**ADDENDUM  
NO. 9**

**June 17, 2022**

**Greenfield Central High School Auditorium Renovation and  
Addition – Bid Package No. 2  
810 N. Broadway  
Greenfield, IN 46140**

**PROJECT: GREENFIELD CENTRAL – AUDITORIUM RENOVATION AND ADDITION**

**MECHANICAL DUCTWORK PLAN - SECOND FLOOR - UNIT L**  
 SCALE: 3/32" = 1'-0"

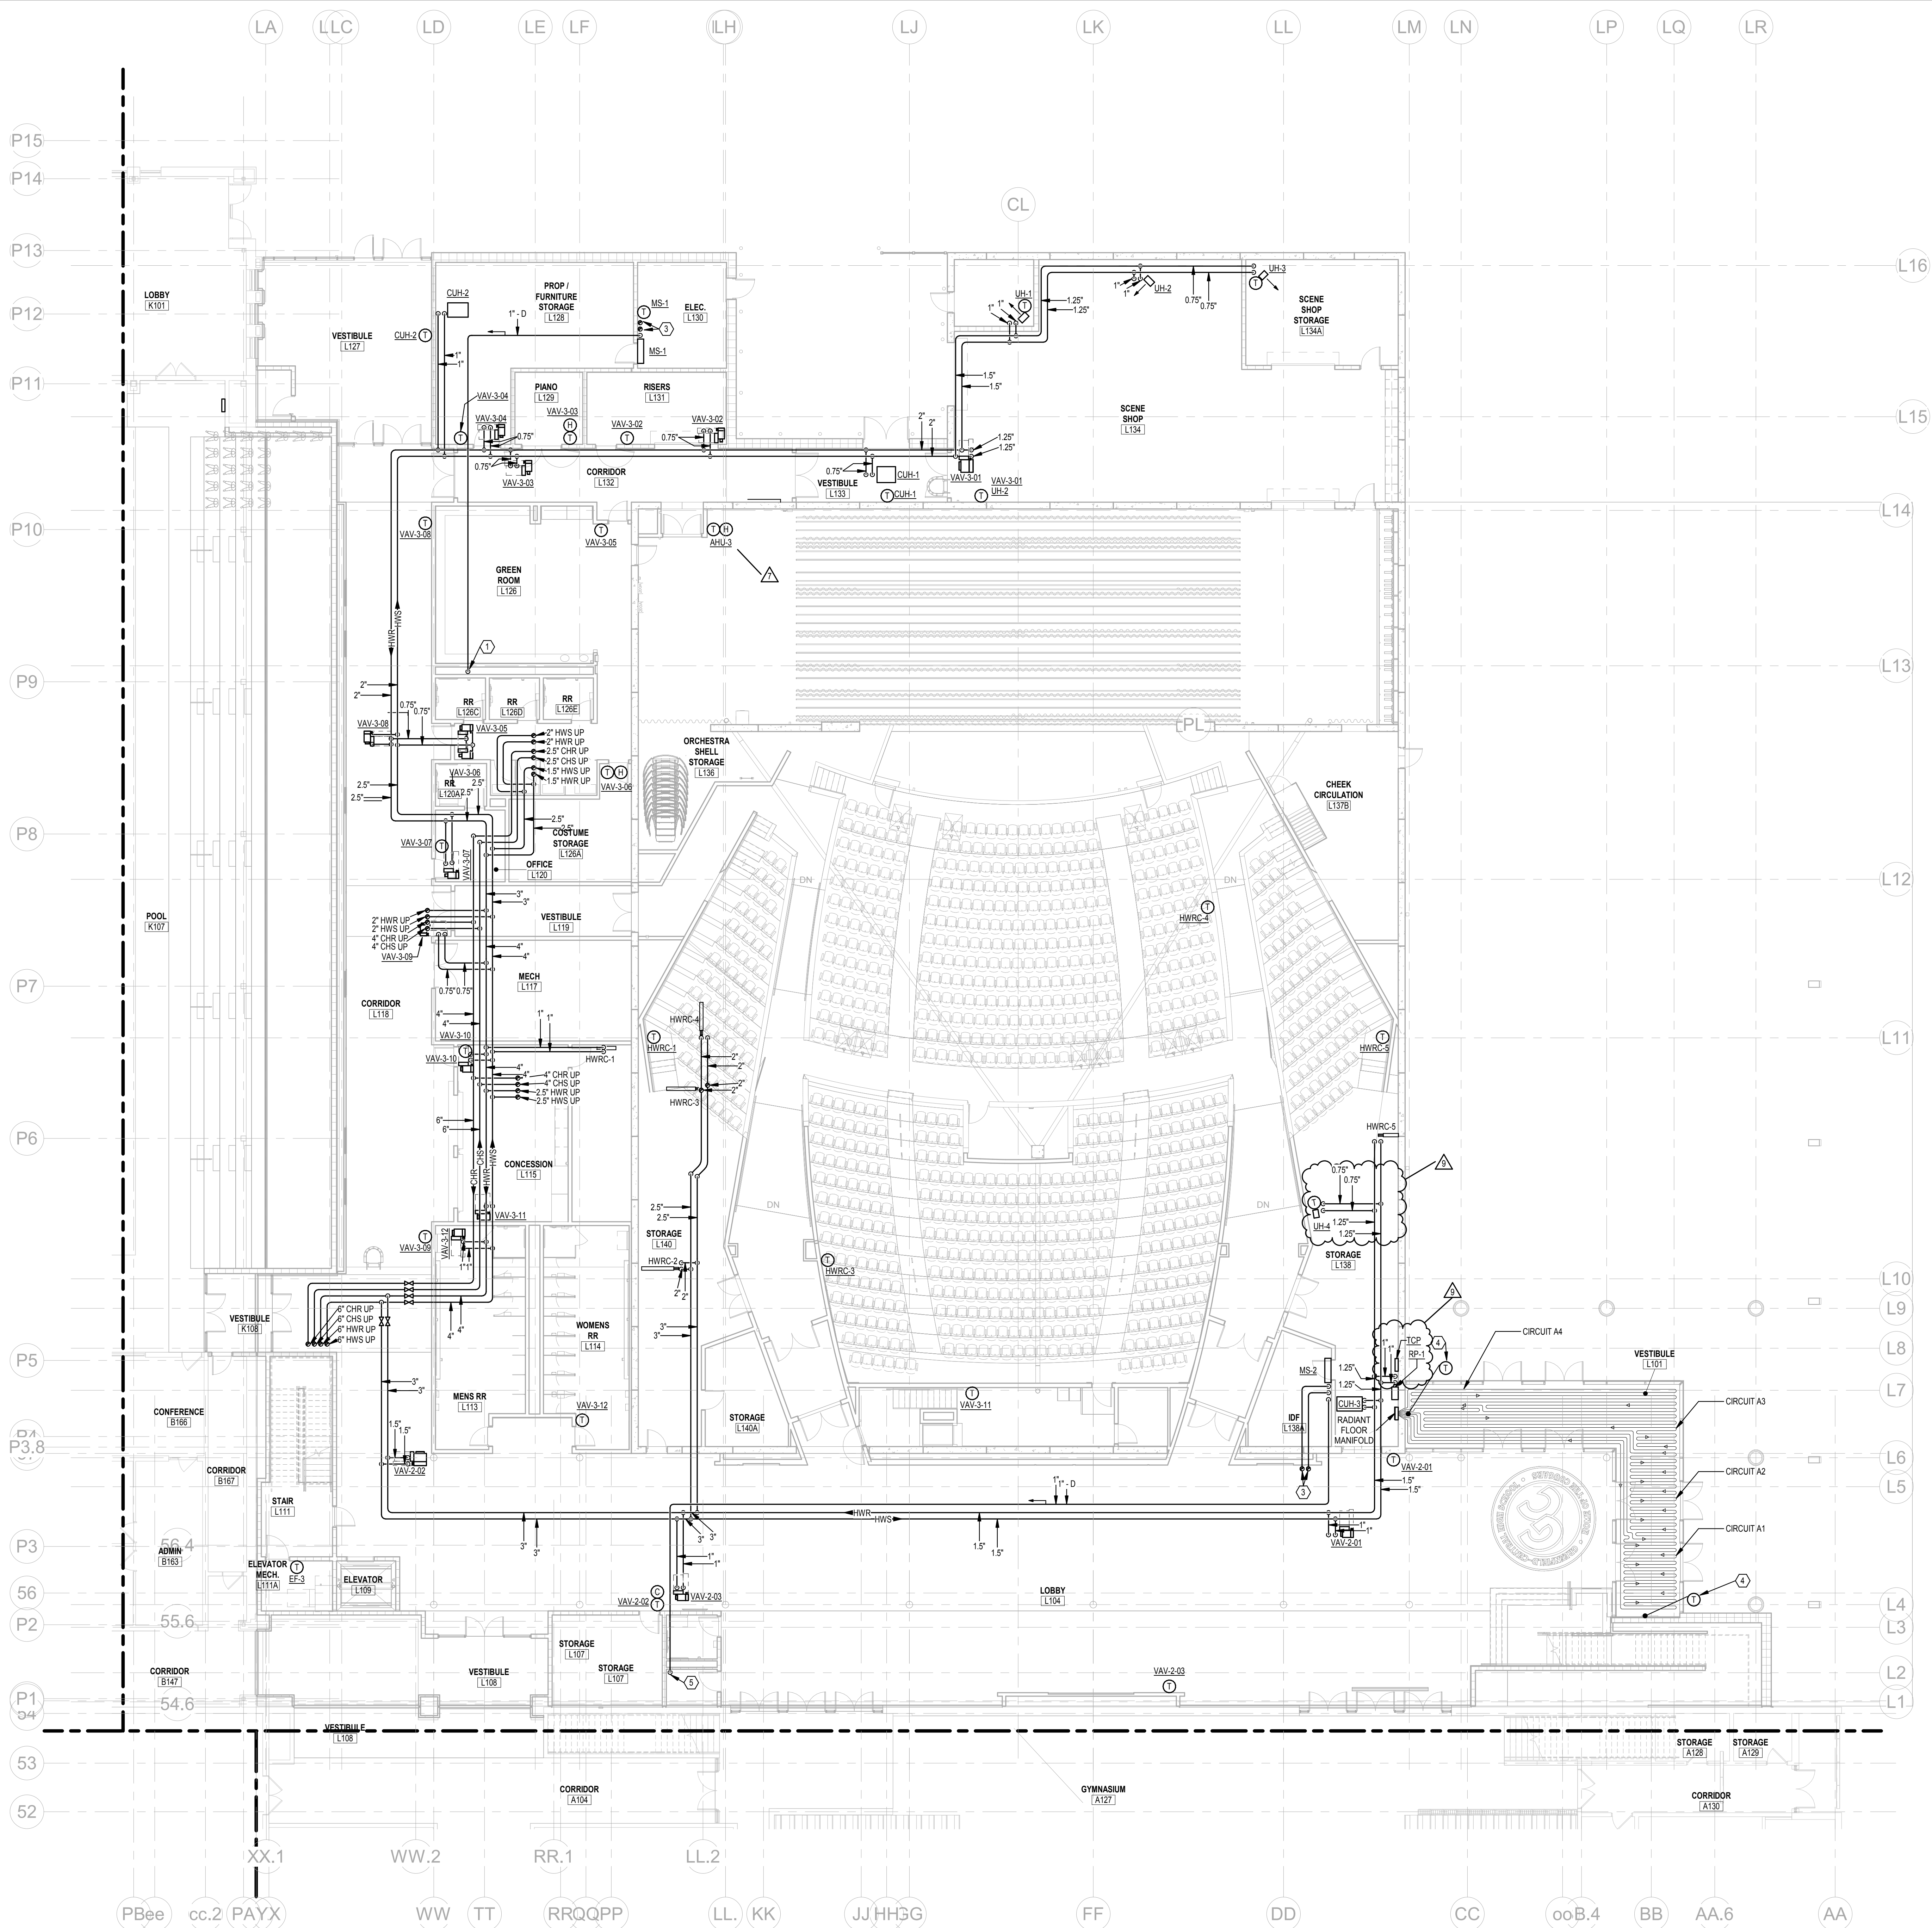
- C. Add TCP in L138.
- ITEM NO. 16 M102L - MECHANICAL DUCTWORK PLAN - SECOND FLOOR - UNIT L
  - A. Add temperature control panels in L214.
  - B. Add unit heater 5

- C. Modify stage ductwork.
- ITEM NO. 17 M201L - MECHANICAL PIPING PLAN - FIRST FLOOR - UNIT L
  - A. Add UH-4 and piping.
  - B. Add TCP in L138.
- ITEM NO. 18 M202L - MECHANICAL PIPING PLAN - SECOND FLOOR - UNIT L

**RETURN DUCT SECTION**  
SCALE: 1/4" = 1'-0"

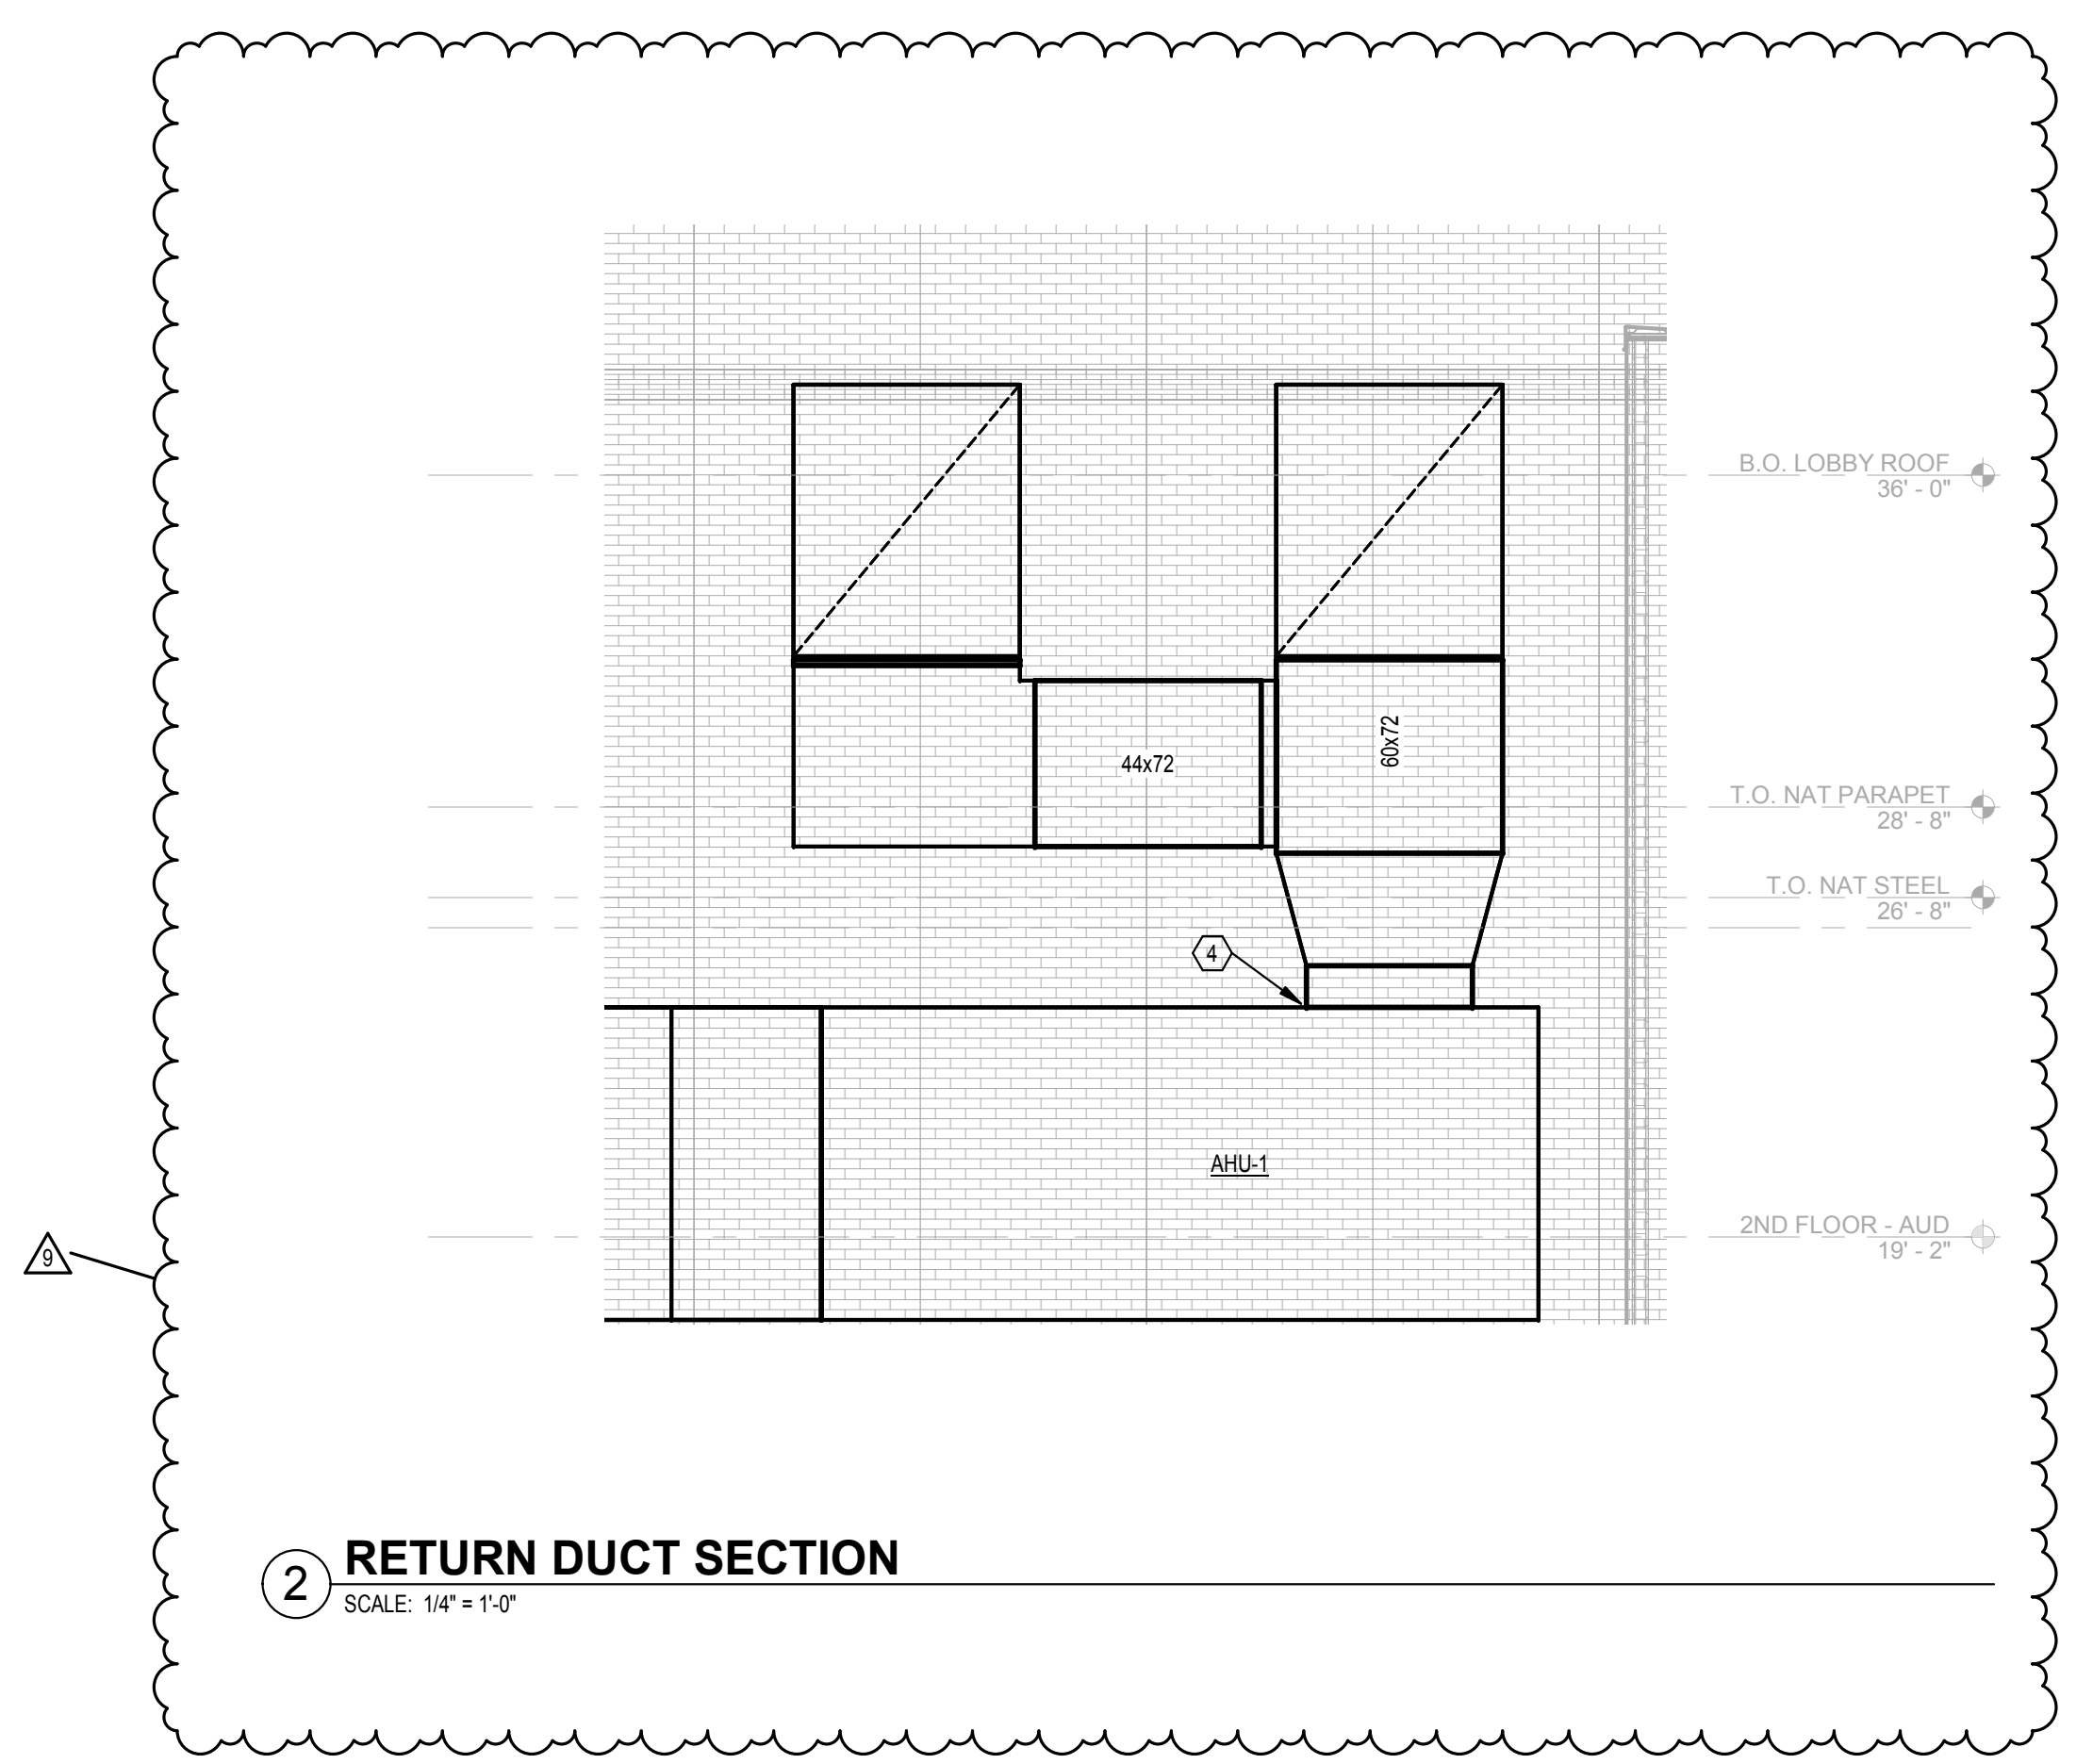
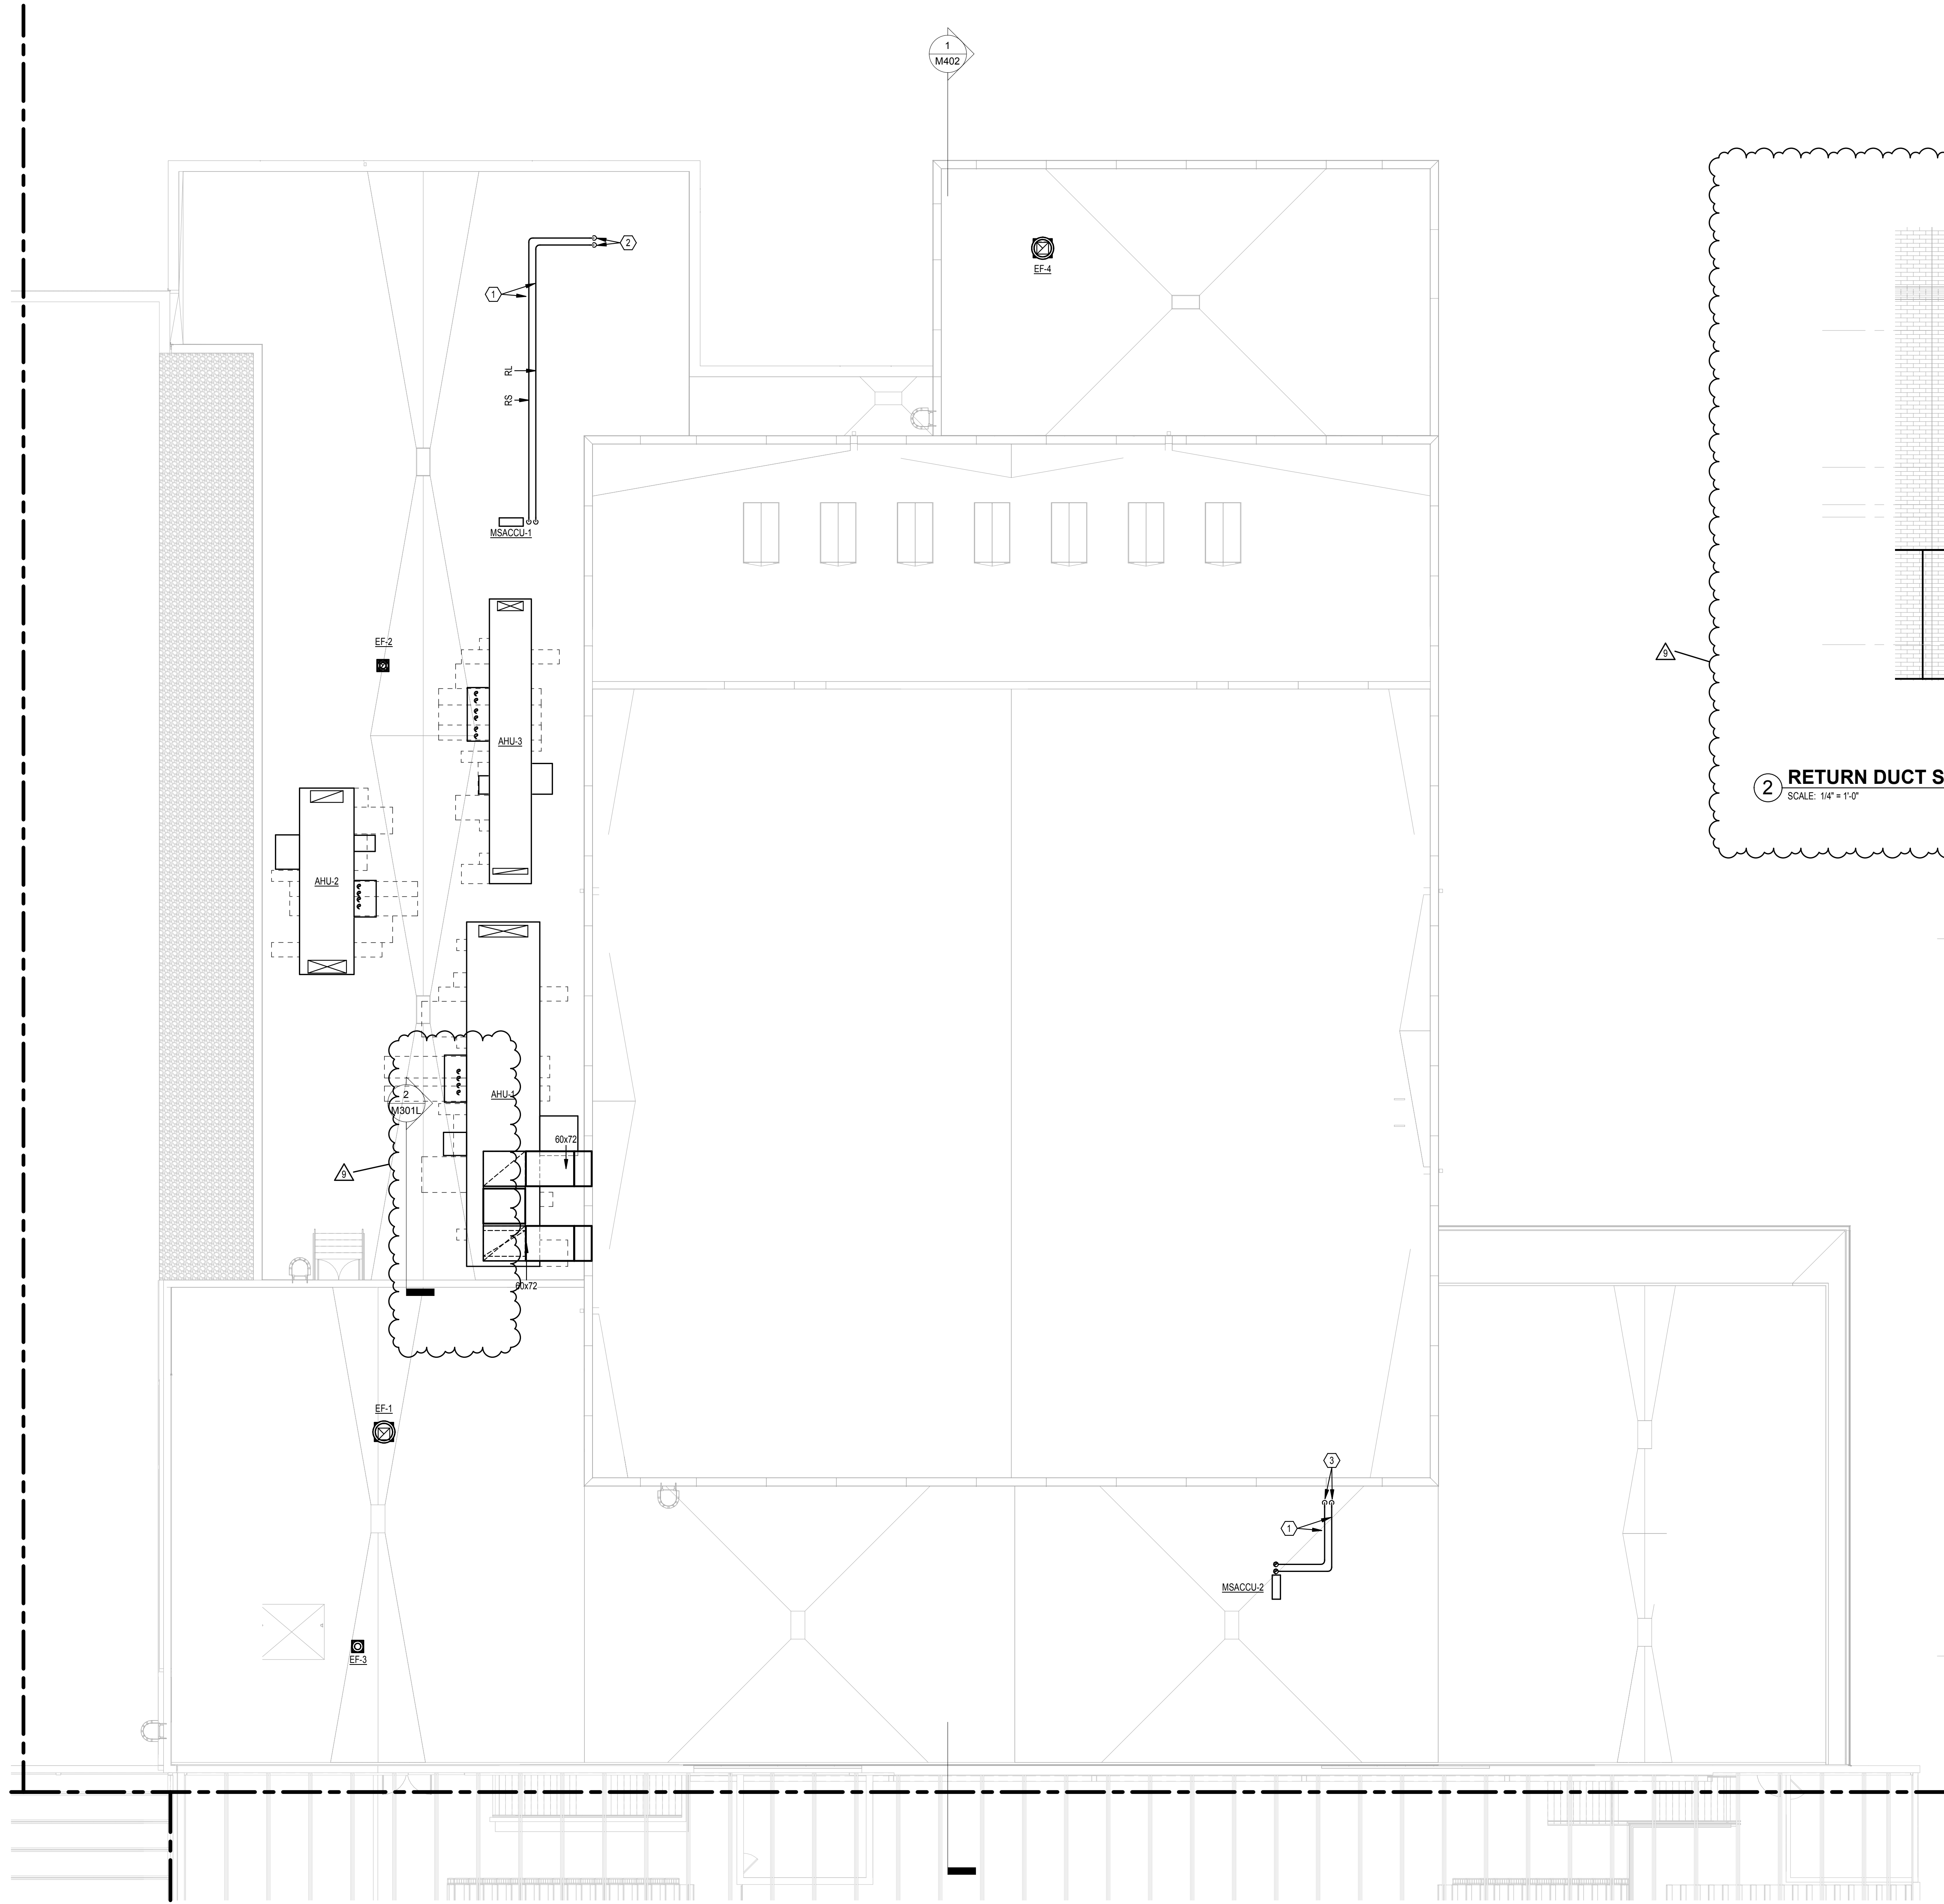
- A. Add temperature control panels in L214.
  - B. Add UH-4 and piping.
- ITEM NO. 19 M301L - MECHANICAL ROOF PLAN - UNIT L
  - A. Add section view.
  - B. Add note 4.
